ND-09-1190

Southern Nuclear Operating Company
Vogtle Electric Generating Plant Units 3 and 4 Combined License Application
Supplemental Response to Request for Additional Information Number 02.04.02-1

Supplemental Response to NRC RAI Number 02.04.02-1

Revised FSAR Figure 2.4-201a

Figure 2.4-201a
Cross-Section Location Map for HEC-RAS Model of Local PMF for Units 3 and 4

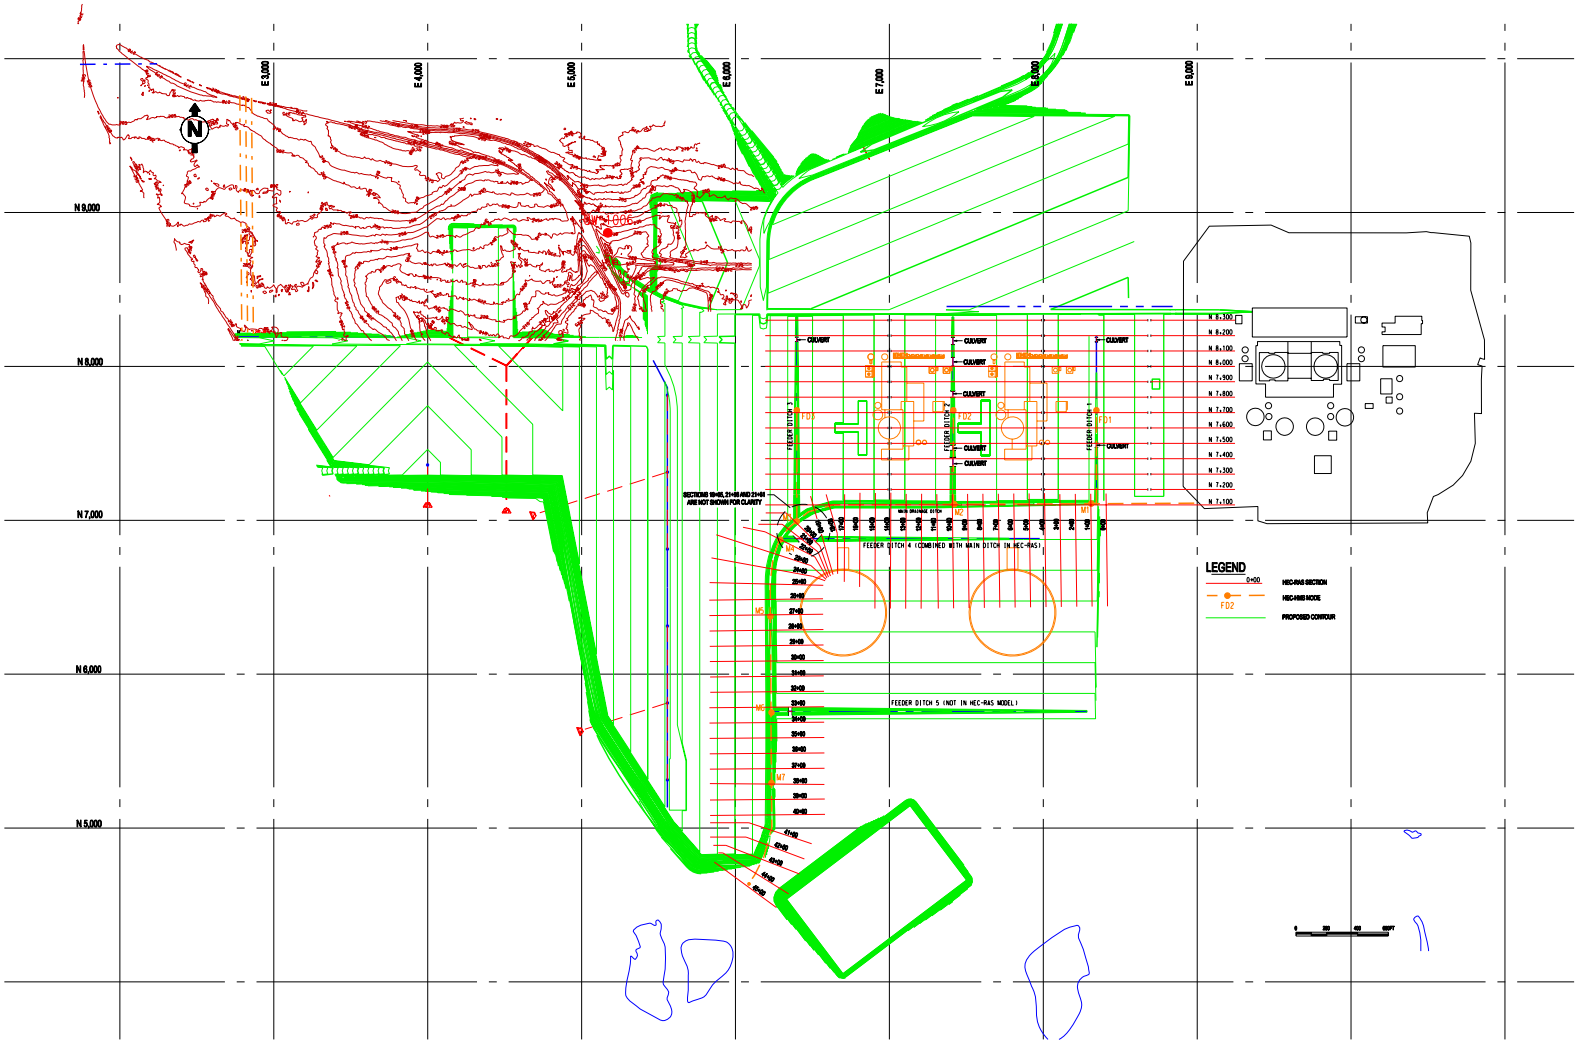
In a telephone conference to discuss the SNC response to NRC RAI Number 02.04.02-1 on April 21, 2009, the NRC noted that the culvert at the downstream end of Feeder Ditch 4 was not included in the hydraulic model. SNC responded that the changes to the probable maximum precipitation (PMP) flood water surface elevation within the power block area would be minimal, since the culvert would be located in the backwater of the main ditch, resulting in low velocities and head loss. However, SNC agreed to an NRC request to reevaluate the maximum water surface elevation with the blocked culvert included in the model.

In a follow-up telephone conference on May 8, 2009, SNC reported that preliminary revision of the cross-section geometry in the hydraulic model to include the culvert in question had resulted in a small increase in the maximum water surface elevation, as anticipated – i.e., 0.02 feet (from 219.45 to 219.47 feet). The NRC also noted a bottom width variation in a cross section in the main channel and requested that this section (and any others as necessary) be adjusted and included in a revised hydraulic model of the PMP drainage system. The NRC further requested a copy of the revised hydraulic model input files for their evaluation and reference.

culvert in Feeder Ditch 4 is accounted for by adjusting cross section geometry to indicate the ditch is filled in at the culvert location.

5. COL Application Part 2, FSAR Figure 2.4-201a will be revised as shown in Enclosure 2.

This supplemental response to RAI Number 02.04.02-1 provides the results of the revised HEC-RAS model for local PMP flood level analysis of the VEGP Units 3 and 4 power block area. FSAR changes reflecting results from this updated hydraulic model are provided below for FSAR Subsections 2.4.2.3 and 2.4.10, Tables 2.0-201 and 2.4-207, and Figure 2.4-201a. Additionally, revised model input files are provided on compact disc (CD) in Enclosure 3.
